Proposed amendments of the three-point bending certification test figure

Proposed figure

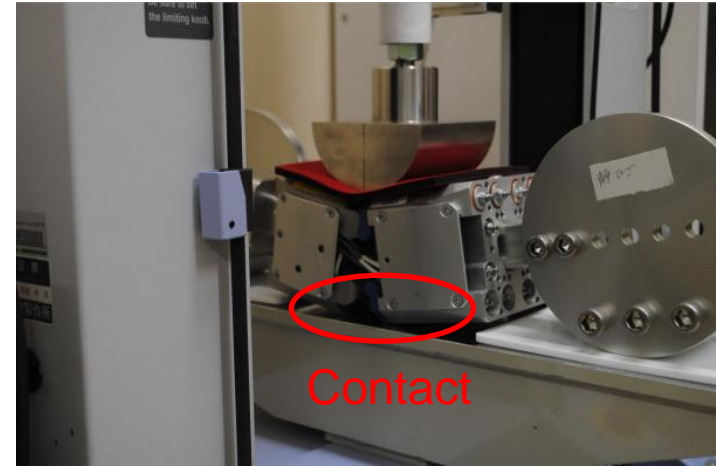
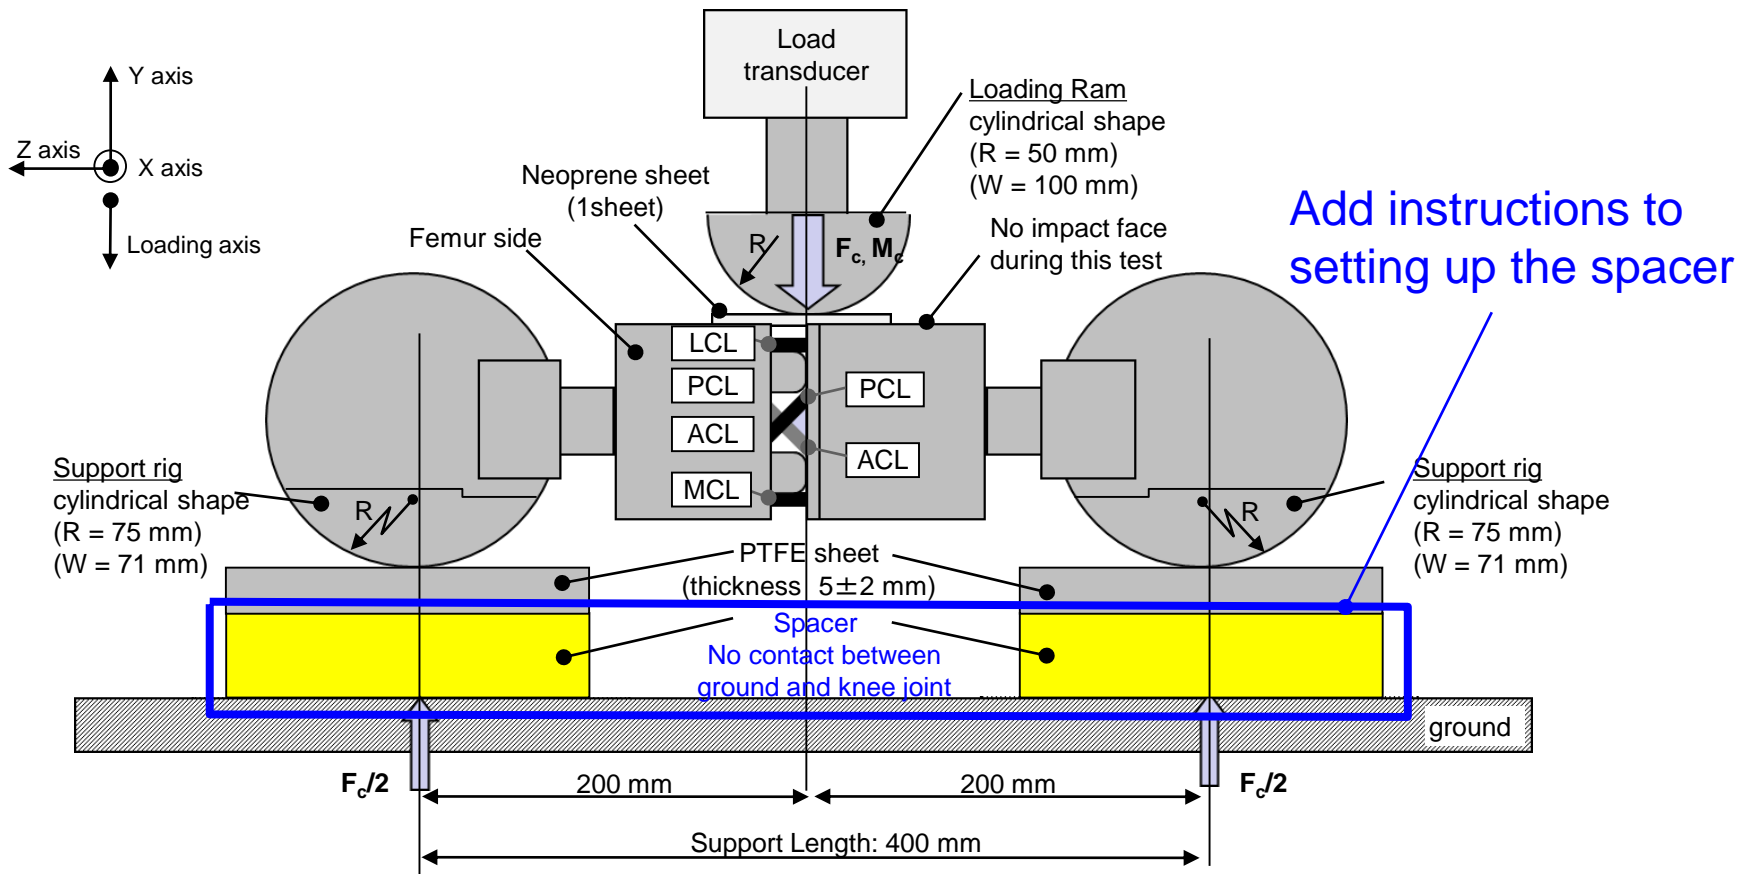
When performing certification tests according to the figure, the ground and knee makes contact.

Instructions for setting up the spacer to prevent contact have been added to the figure.
